Detailed Site Plan
Departure
Alternative Compliance
The Marion

DET-2024-007
DPT-2025-0001
ACL-2025-0005

STAFF REPORT

SUBJECT: Detailed Site Plan DET-2024-007
Minor Departure DPT-2025-0001
Alternative Compliance ACL-2025-0005
Type 2 Tree Conservation Plan TCP2-2025-0067
The Marion

Figure 1: Site Plan

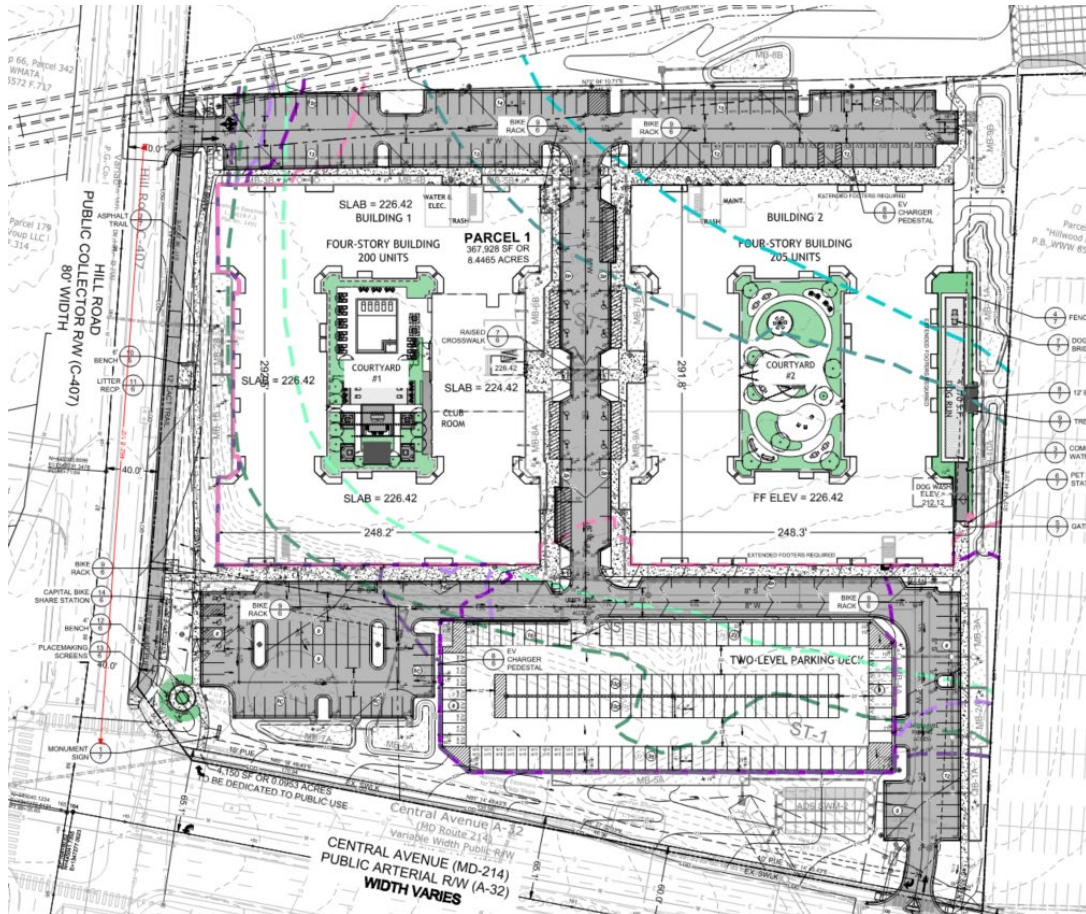
Building 1 is designed to be oriented toward Hill Road, while Building 2 will face inward toward a central private driveway, and to the rear of Building 1 beyond. The property has two vehicular access points; one on Hill Road, which is the primary entrance to the site, located approximately 460 feet from the intersection of MD 214 and Hill Road. The secondary access point is located at the southeastern corner of the site on MD 214 and will accommodate right-in/right-out traffic only. These access points serve a private, internal driveway that extends through the property, connecting parking areas.

A two-level brick parking structure is proposed along MD 214. Site constraints such as floodplain on the north side of the site and the presence of large utility poles along the MD 214 right-of-way (ROW) presented challenges in site layout. There is also significant grade change from the west side of the site to the east. The parking structure will utilize this grade change to be less visible from MD 214. While staff find that in general, parking should be located to the rear of a site, and that buildings should front MD 214, the proposed layout addresses the site's challenges of topography and the presence of large utility poles, while providing high quality street frontage improvements. Special attention has been paid to the streetscape, including significant landscaping and a mural that will be located on Building 2, facing MD 214 and continue along the east and south sides of the parking structure.
